<b>Project:</b>	Ravensdown Awatoto Consent Application		
<b>Our reference:</b>	343853BA18	<b>Your reference:</b>	Ravensdown
<b>Prepared by:</b>	Simon Liddell, Nick Dempsey & Sven Exeter	<b>Date:</b>	3 March 2022
<b>Approved by:</b>	Sven Exeter	<b>Checked by:</b>	Simon Liddell, Nick Dempsey & Sven Exeter
<b>Subject:</b>	Ravensdown Review

## 1 Introduction

Figure 1: Site Map with Stormwater Catchments

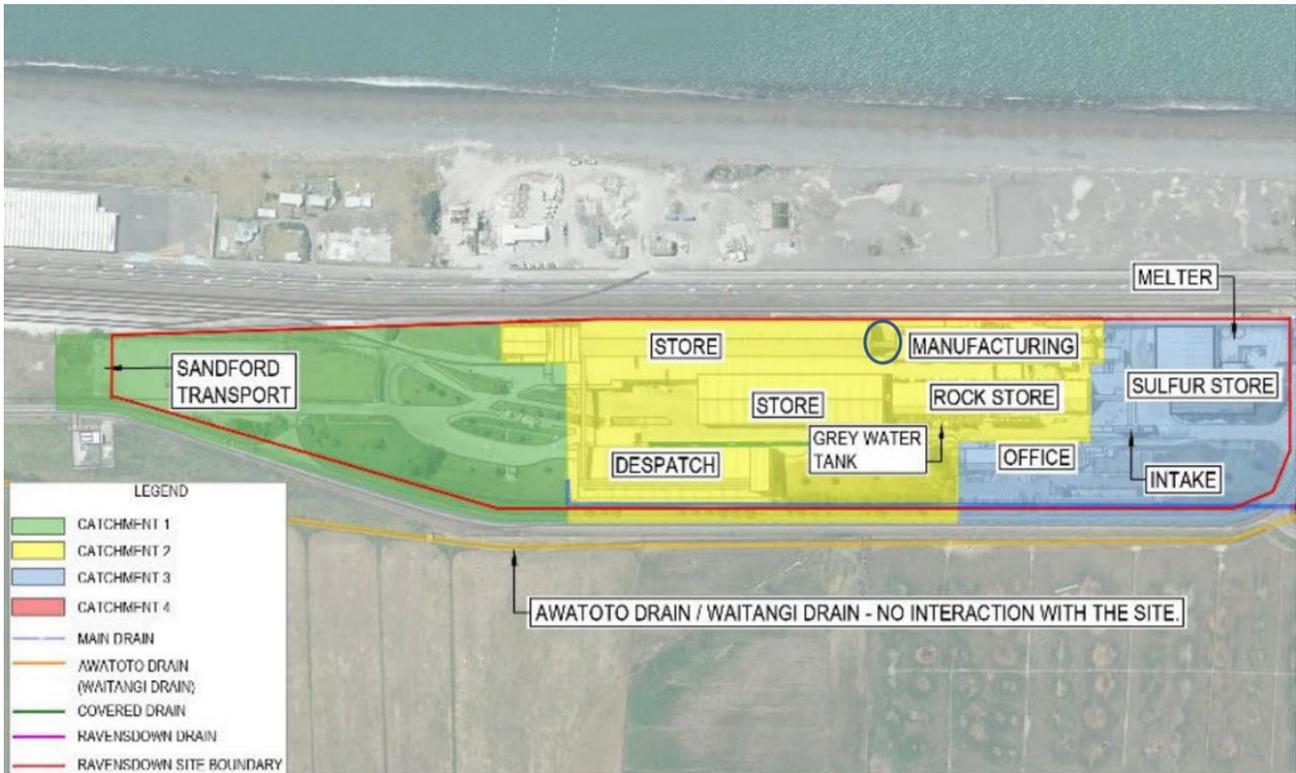
- The bulk storage area vehicle access and lanes and adjacent access areas (i.e. not storage per se) were coated in raw fertiliser material. At both of these areas, there was significant airborne fugitive dust. Mechanical mobile sweepers have had clogging issues and were not operating. There appeared to be a “wind tunnel” between the storage and manufacture buildings and dust was seen migrating towards State Highway 51 from the outdoor uncovered hardstand area adjacent to the bulk storage area (between Superstore 1 and the Manufacture Plant – refer to blue circle on below Figure 1). At this uncovered outdoor area is a surface channel drain that would appear to receive stormwater containing with phosphate rock dust. Andrew Torrens advised that this exposed outdoor area will be covered with a new roof and drainage system between the Superstore 1 and the Manufacture Plant buildings (refer to Figure 2 and Figure 3).

53. It is unclear if the area between Superstore 1 and the Manufacture Plant (refer to Figure 1 and Figure 2 above) is covered under the action schedule so this needs to be clarified. Please confirm that this area is covered in the action schedule.

Figure 9: TANK Taradale and Awatoto SPZ with Napier City Council Water Supply Wells

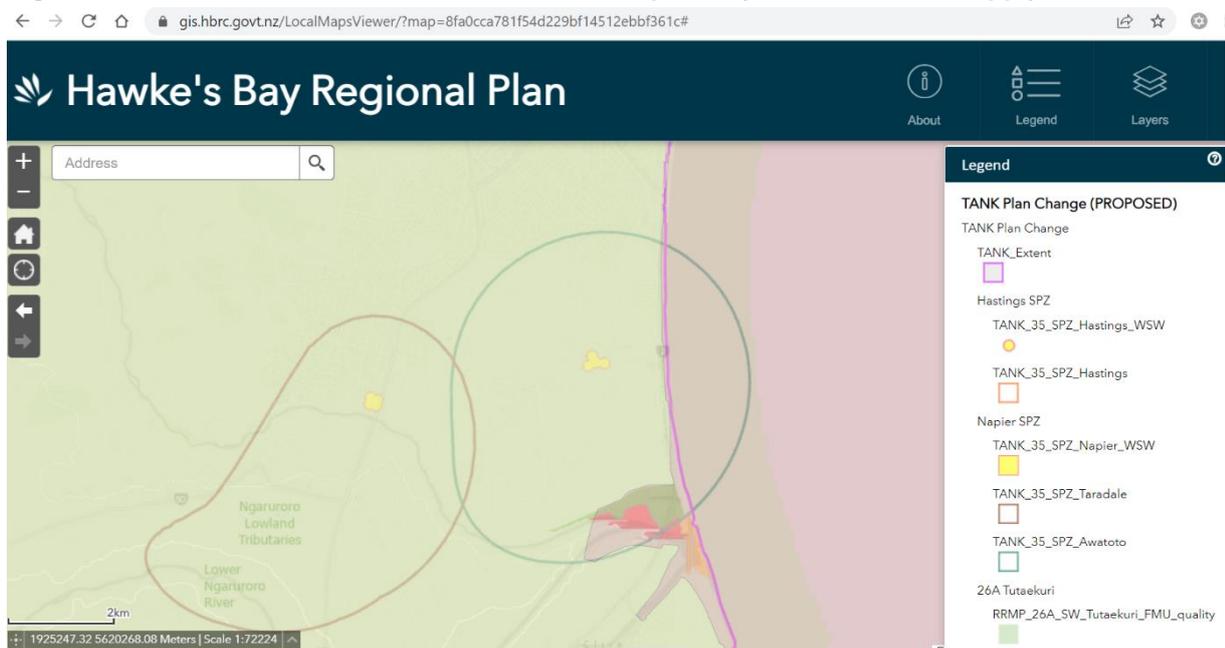
No map of the source protection zone with site location is included. Source protection zone (SPZ) map information is readily available from the HBRC web site (refer Figure 9 below).

11. Provide a map of the SPZs with the full site boundary including the land discharge area. The names of the SPZs and distances from or if the site is included within a SPZ should be provided in the Appendix and where relevant in existing text that refer to the SPZ, notably the Executive Summary.

**Figure 10: Suggested Monitor Well Locations**

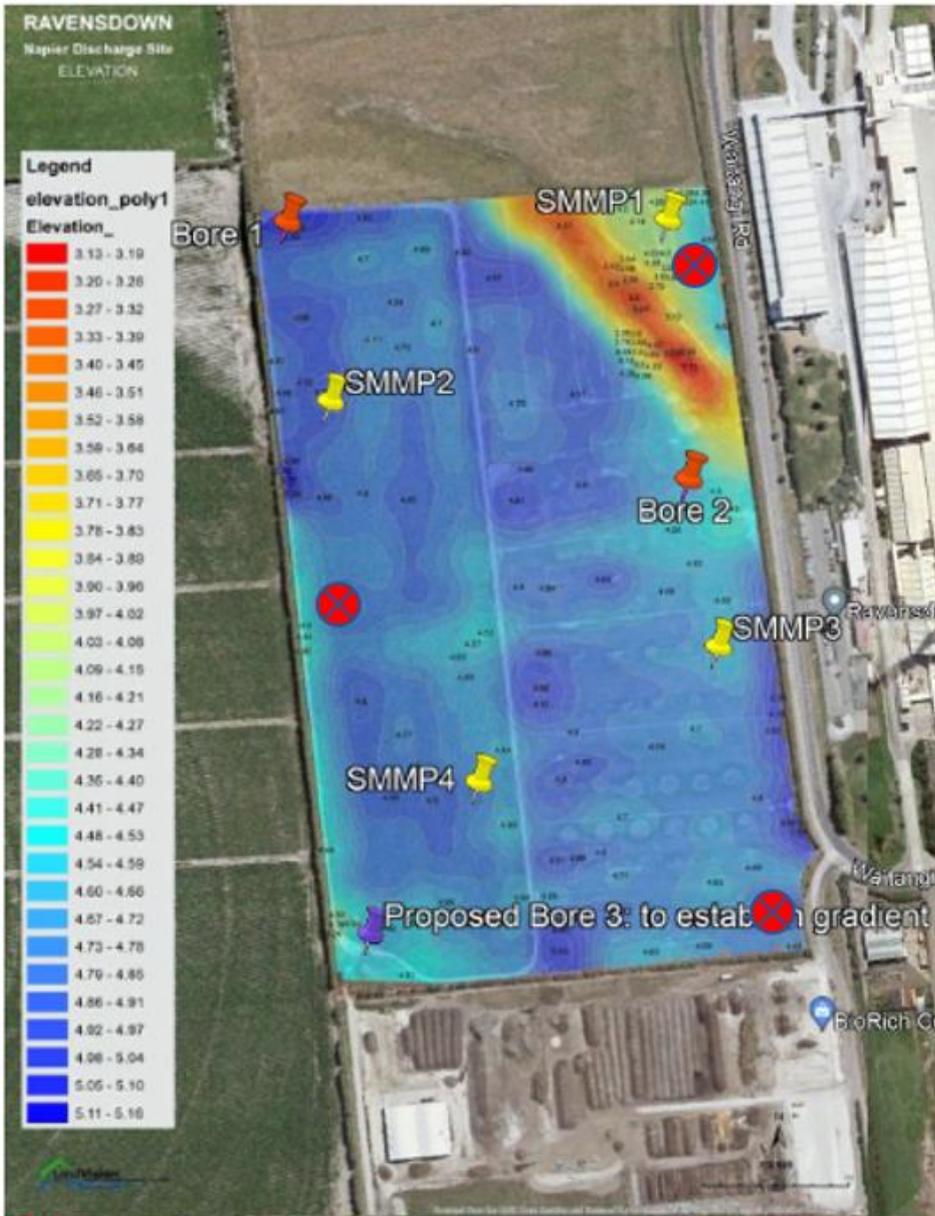
The potential for contaminants to migrate down hydraulic gradient (i.e. towards the sea) off the Ravensdown site is the primary concern for this consent, not the migration of contamination onto the Ravensdown site from the upstream site. Therefore, the greatest number of wells (two) should be on the downgradient location suitably set back from the canal to ensure that the sites groundwater conditions are primarily characterised.

12. Please consider and provide commentary on the revised well locations (refer Figure 10 below with recommended locations) and increase the number of sampled monitoring wells to all three wells.

Suggested relocation of three monitoring wells
